Access Compliance Report

Public Rights-of-Way

Intersection ID: 50601	Main Street: LUSTERLEAF HOLLY RD	Cross Street: HEARTLEAF RD	Location: W
ADA ID: AE369A942A11	Ramp Type: BlendTrans1	Initial Pass/Fail: Pass	Overall Compliance: No
Severity Score: 5			
Codes/Mitigation Info/Possible Solution		Field Measurements/Component Compliance

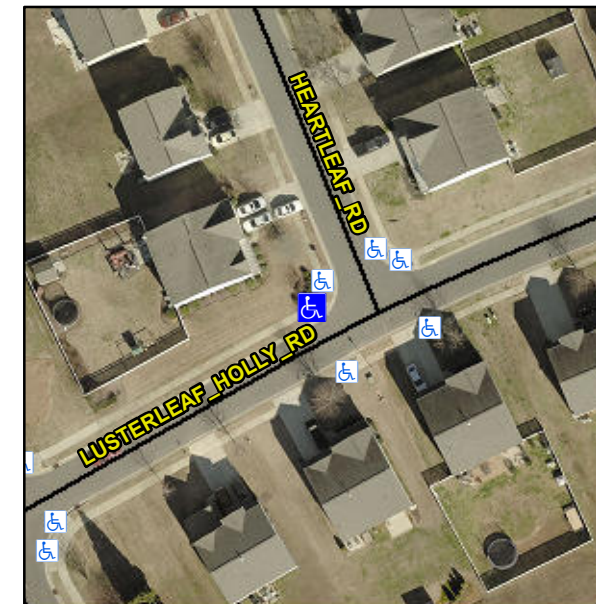
Not Found, R304.2.1, R304.2.2-Perp, R304.3.2-Para, R305.2, R304.5.4

Compliance	Description	Data	Compliance	Description	Data
N/A	Ramp Length (in)	48.0	Yes	BlendTrans Slope (%)	4.0
Yes	Ramp Width (in)	48.0	Yes	BlendTrans XSlope (%)	0.6
N/A	Flare Type LT	Sloped	N/A	Flare Type RT	Sloped
N/A	Flare Slope LT (%)	3.7	N/A	Flare Slope RT (%)	3.4
N/A	Flare Traversable LT?	No	N/A	Flare Traversable RT?	No
No	Landing Length (in)	47.5	Yes	DWS Provided?	Yes
Yes	Landing Width (in)	82.0	Yes	DWS Contrast?	Yes
No	Landing Slope (%)	4.1	Yes	DWS Length (in)	24.5
Yes	Landing X Slope (%)	0.2	Yes	DWS Full Width?	Yes
N/A	Landing Curb? (Y/N)	Yes	No	DWS Offset (in)	6.0
N/A	Shared Landing?	No			
Yes	Gutter Ponding?	No	No	Gutter Slope (%)	9.7
Yes	Gutter Lip Ht (in)	0.0	Yes	Gutter X Slope (%)	0.9
N/A	Painted X Walk1?	No	N/A	Painted X Walk2?	N/A
	X Walk 1 Direction	To S		X Walk 2 Direction	N/A
	X Walk 1 Width (in)	N/A		X Walk 2 Width (in)	N/A
	X Walk 1 Slope (%)	2.6		X Walk 2 Slope (%)	N/A
	X Walk 1 X Slope (%)	0.0		X Walk 2 X Slope (%)	N/A

N/A	Ramp inside XWalk1?	N/A	N/A	Ramp inside XWalk2?	N/A
	Road Slope (%)	0.0		Clear Space?	Yes
	Road X Slope (%)	2.6	N/A	Clear Space to XWalk (in)	N/A
Yes	Any Obstructions?	No	Yes	Storm Grate/Utility Hazard?	No
	Obstruction Type			Storm Grate/Utility Type	
			N/A		N/A
			Yes	Surface Condition? (G/P)	Good
			No	Curb Slope (%)	10.4

Remove & Replace Curb Ramp With Two New Directional Ramps or Equivalent. Remove & Replace Gutter.
